Application for Approval of a Definitive Subdivision Modification

**Subject: Maple Lane Subdivision Modification
10 Rugged Road
PLSUB 2021-08-00195**

DEFINITIVE SUBDIVISION PLAN
MAPLE LANE
10 RUGGED ROAD
NANTUCKET, MASSACHUSETTS
 ASSESSORS MAP 67, PARCEL 303
 PREPARED FOR
 DELFMARK, LP

DRAWING TITLE:
SITE LAYOUT PLAN
 SCALE: **1" = 30'**
 SHEET NO.
4 OF 10

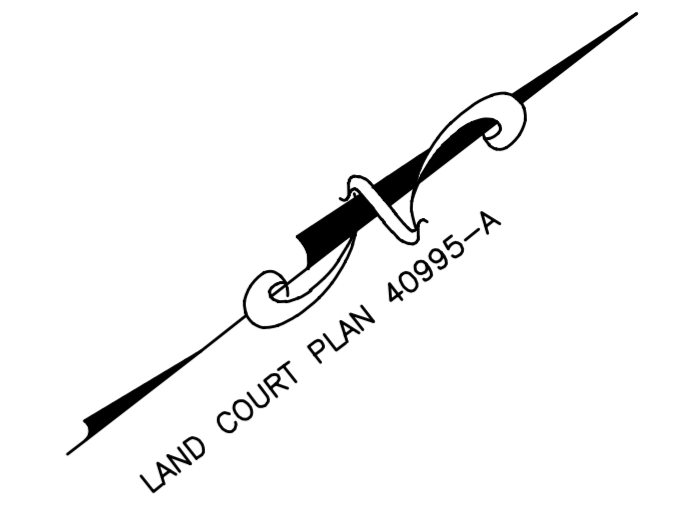
4. Change the location of the end of the sidewalk around the cul-de-sac to terminate at the connection with the sidewalk to Cachalot Lane. The current sidewalk layout extends beyond the Cachalot connection and creates a dead-end sidewalk in front of lot 9, see attached plan markup.
